ADDENDUM NO. 2

January 19, 2023

DUNELAND BRUMMITT ELEMENTARY SCHOOL RENOVATIONS Chesterton, IN 46304

Addendum Two (AD.02) to the drawings and specifications prepared by Gibraltar Design for **Brummitt Elementary School Renovations** for Duneland School Corporation, Chesterton, Indiana.

DRAWING
UNIT "A" FIRST FLOOR FINISH
PLAN

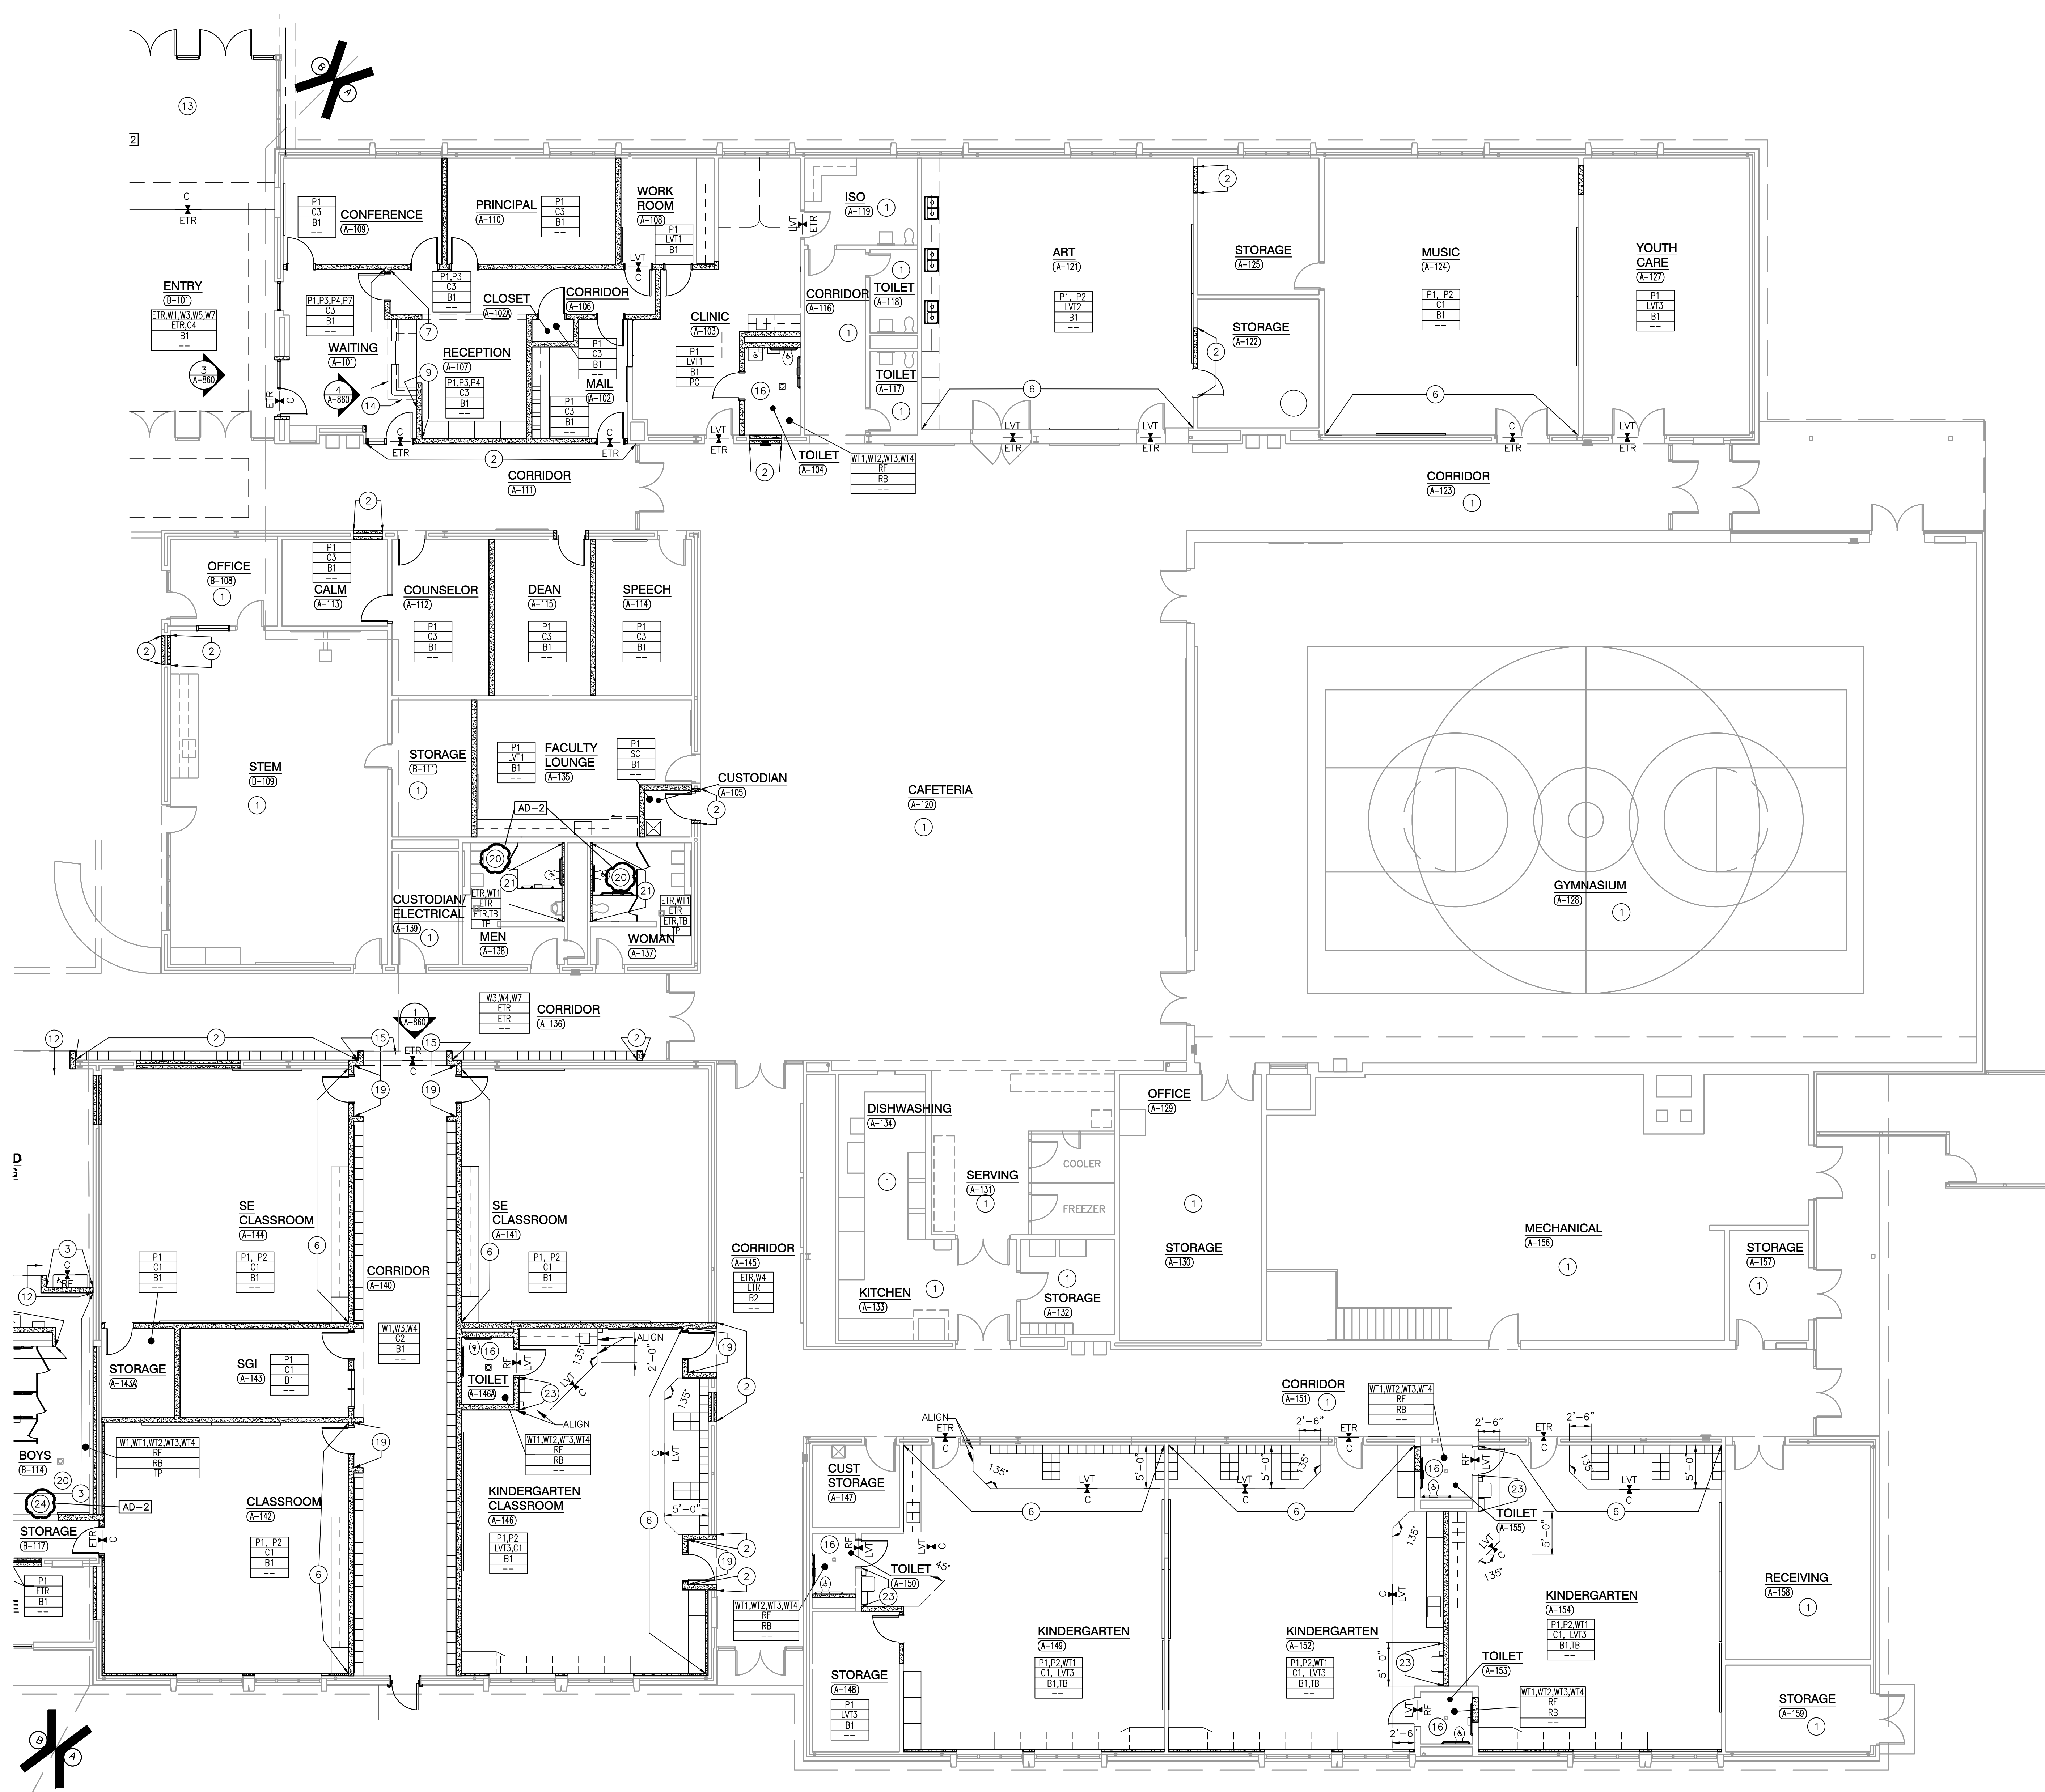
- A. Refer to two (2) revised full size drawings, included in this Addendum, for the following revisions:
1. Change Finish Plan Notes 17 to read "Not Used."
 2. Change Finish Plan Notes 20 to read "Schluter tile trim at all new outside corners."
 3. Change Finish Plan Notes 20 to read "Match existing wall finishes, wall tile full height."
 4. Add Finish Plan Notes 24 to read "Refer to A-101 and A-102 for additional work required for tile installation in this room."
 5. Add note 20 to Woman A-137 and Men A-138.
 6. Add note 24 to Boys and Girls group restroom in Unit B.

DRAWING
UNIT "A" PLUMBING ROOF
PLAN

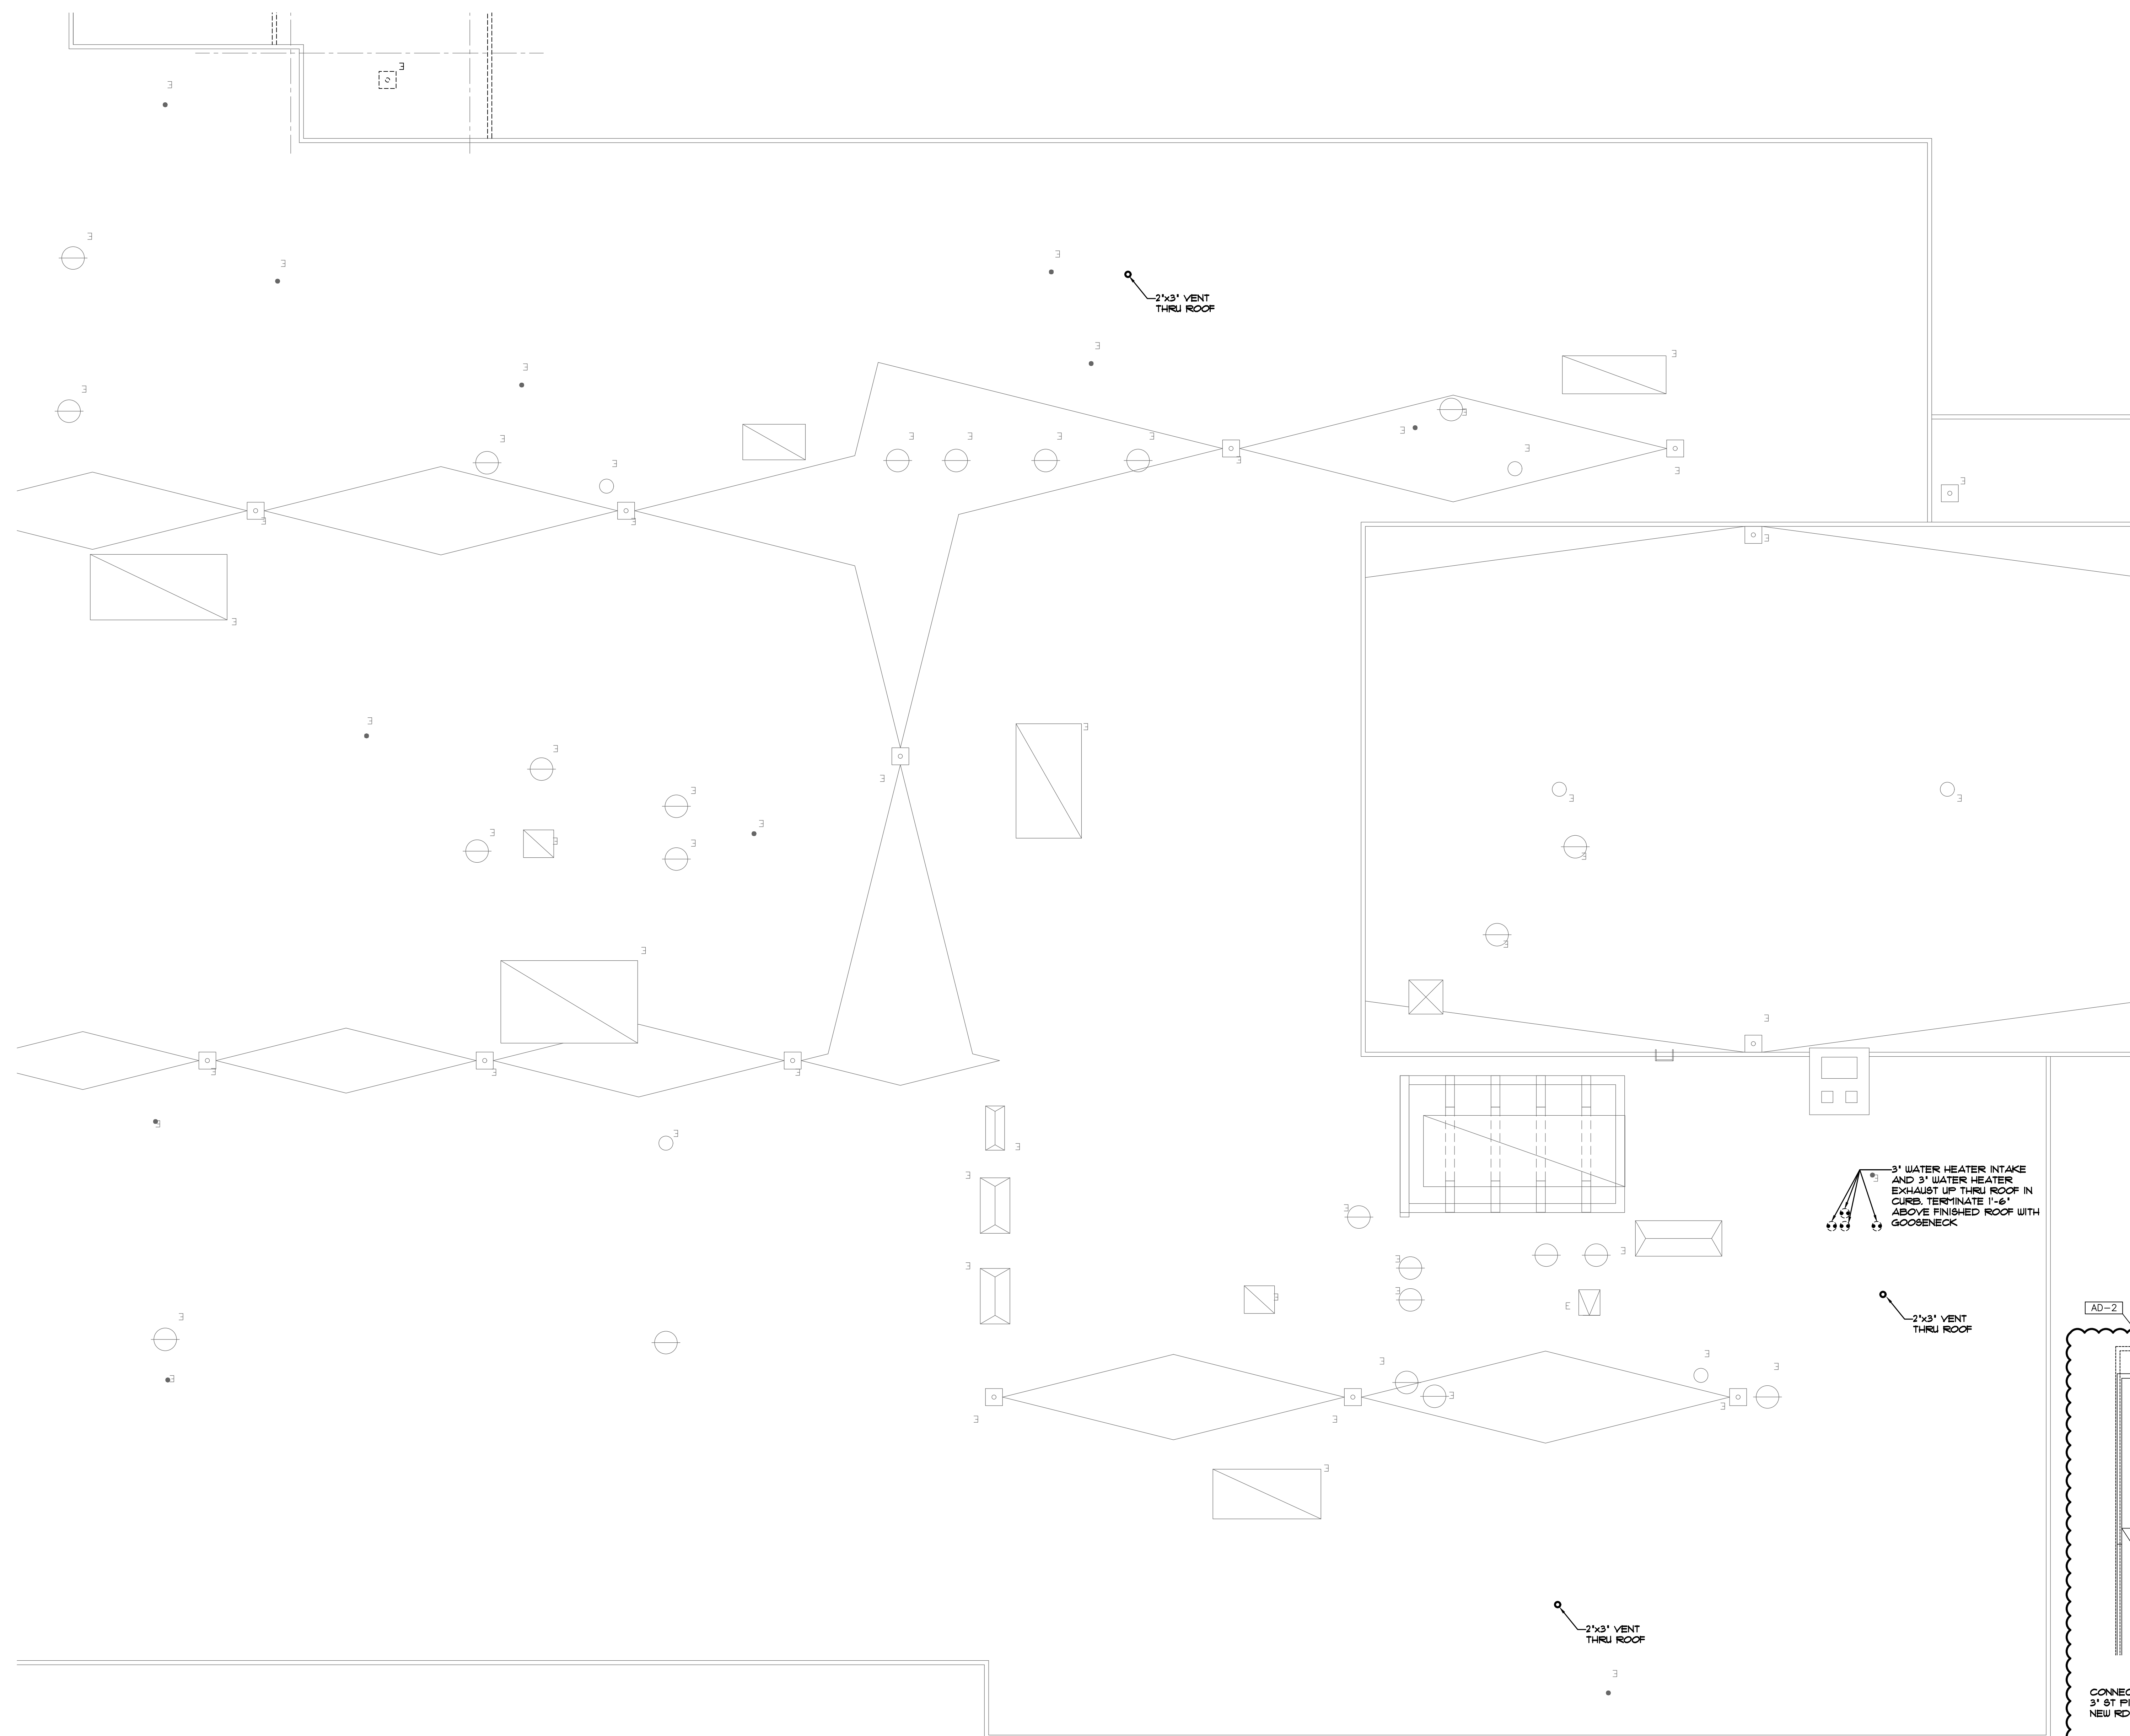
- A. Refer to revised full size drawing, included in this Addendum, for additional information regarding canopy Alternate.

PLUMBING DETAILS

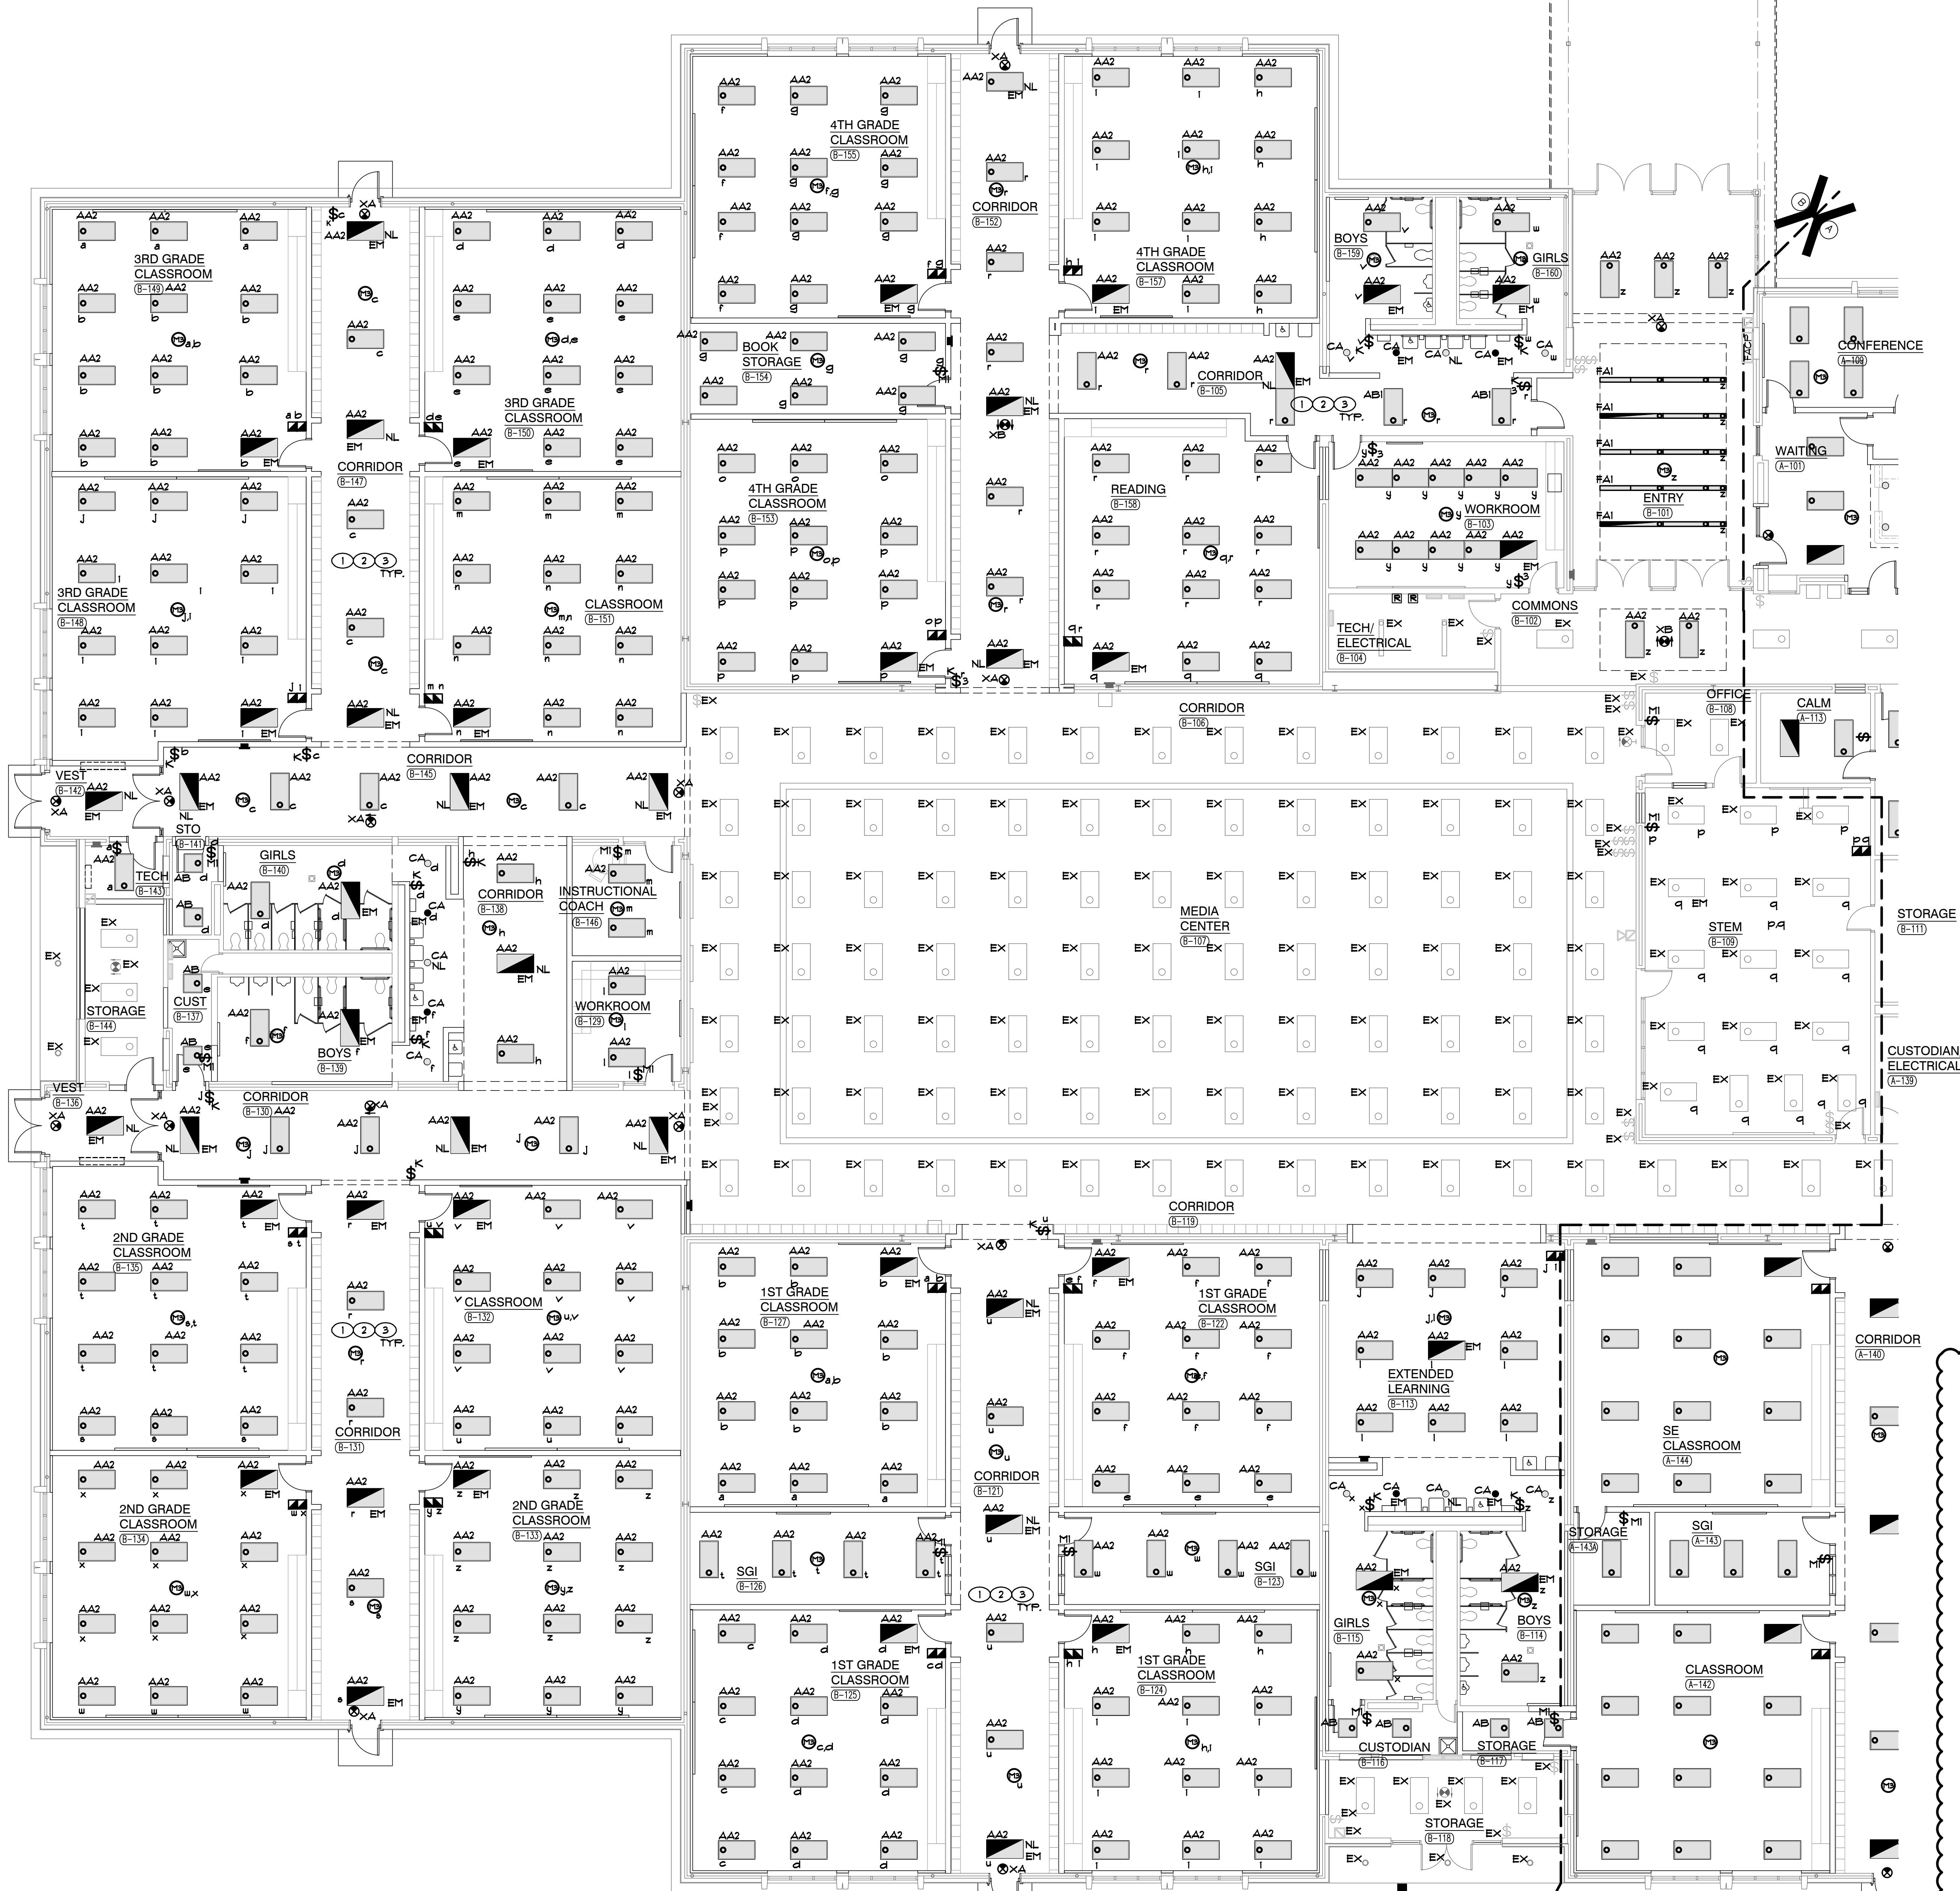
- 1. Add new full size drawing, included in this Addendum, to Construction Documents.
